**ADDENDUM NO. 2 TO  
WIDENING OF PRICE CANYON ROAD  
BETWEEN ORMONDE ROAD  
AND HWY 227 NEAR PISMO BEACH, CA  
CONTRACT NO. 300464  
FEDERAL AID PROJECT NO. RPLCML-5949(074)**

**WIDENING OF PRICE CANYON ROAD  
BETWEEN ORMONDE ROAD  
AND HWY 227 NEAR PISMO BEACH, CA  
COUNTY CONTRACT NO. 300464  
FEDERAL AID PROJECT NO.: RPLCML-5949(074)  
BID PROPOSAL**

ROAD NO.	JOB NO.	SHEET NO.	TOTAL SHEETS
2001	300464	5	47

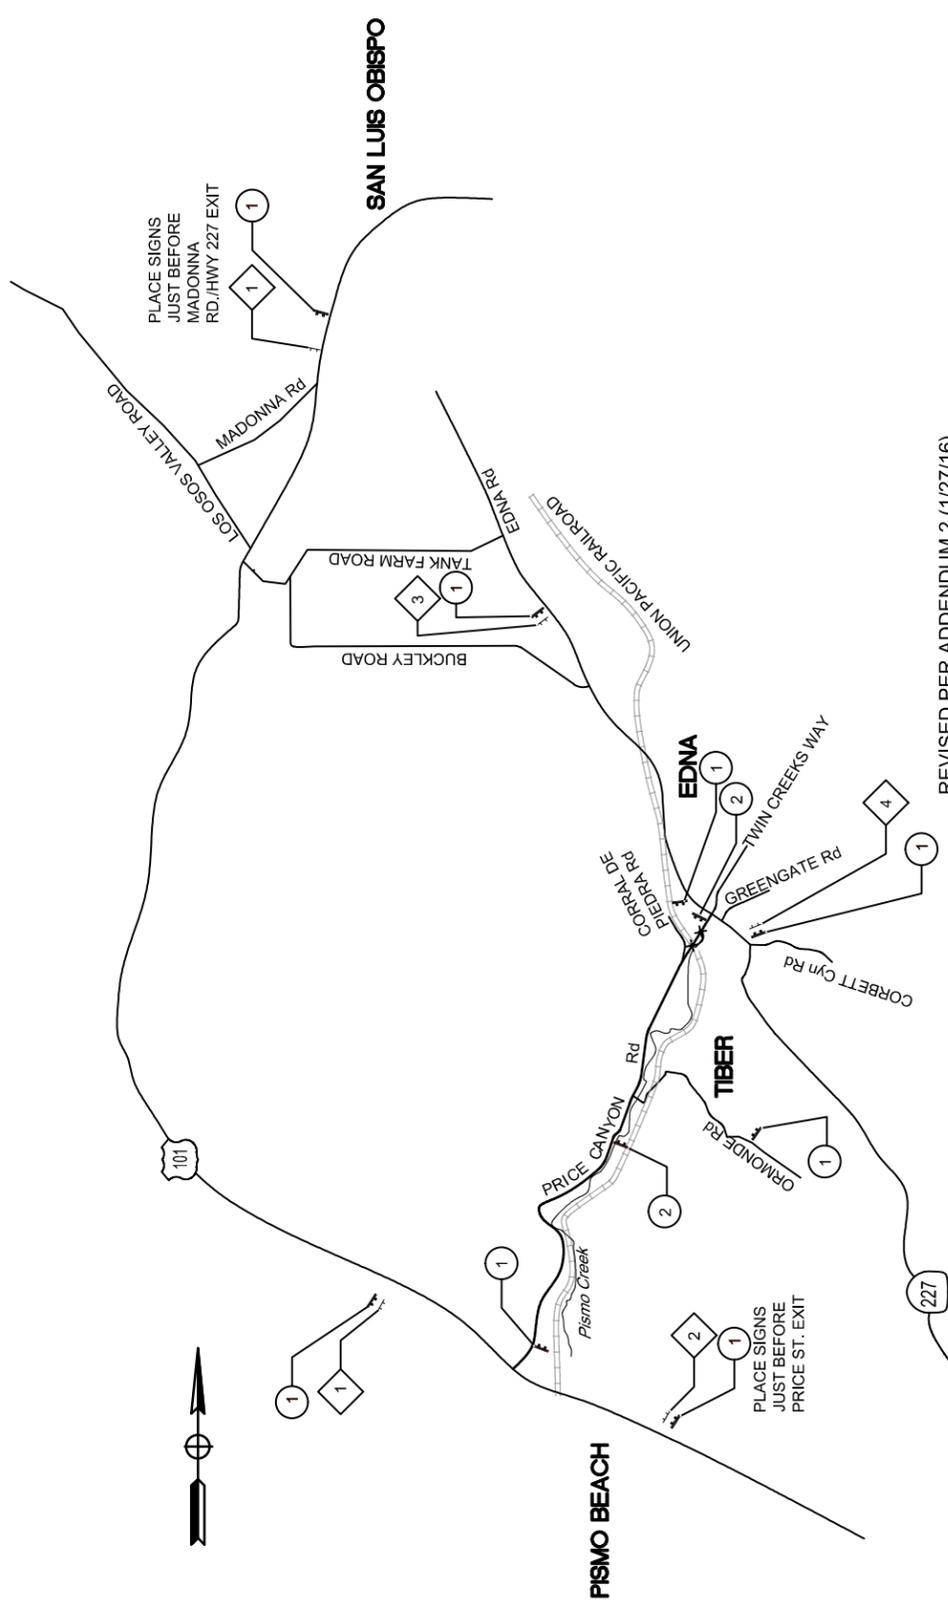
15) Replace entire Sheet 5 of 47 with the revised Sheet 5 attached to this addendum. Attention is directed to Sign A detail, Construction Area Signs table, and Portable Changeable Message Signs table.

REVISED PER ADDENDUM 2 (1/27/16)

## TYPICAL OVERLAND ESCAPE DETAIL

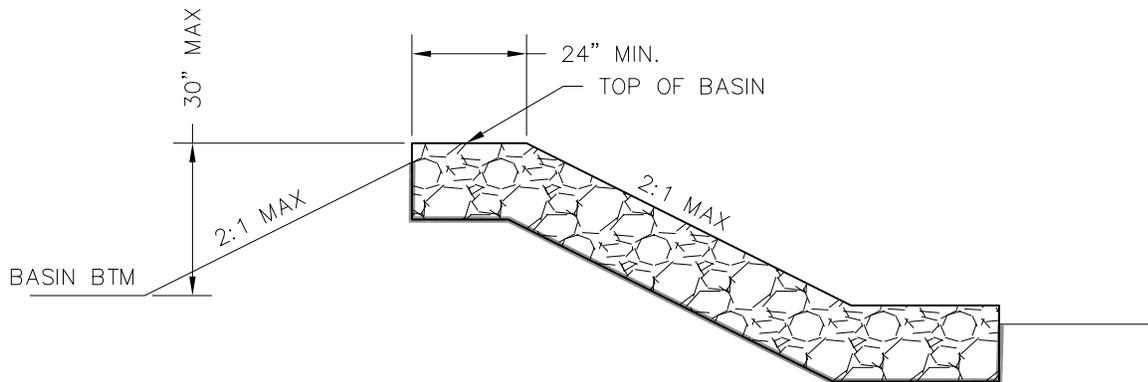
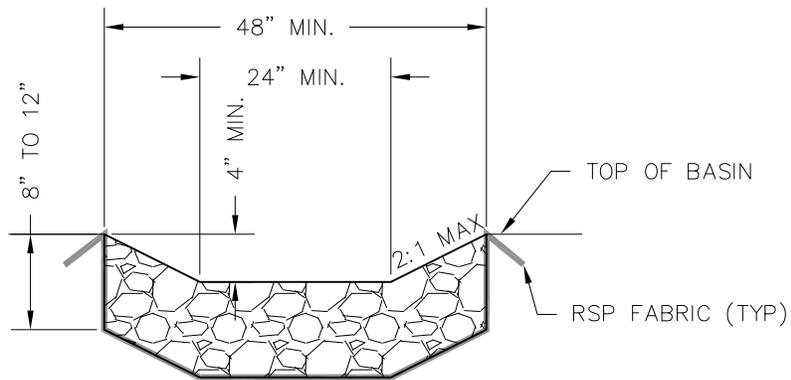
19) Add the attached Typical Overland Escape Detail to Sheet 21 of 47.

"Full compensation for furnishing and placing rock slope protection for overland escapes as shown on the plans shall be considered as included in the contract unit price paid for "ROCK SLOPE PROTECTION (FACING CLASS, METHOD B)", and no separate payment will be made therefore."
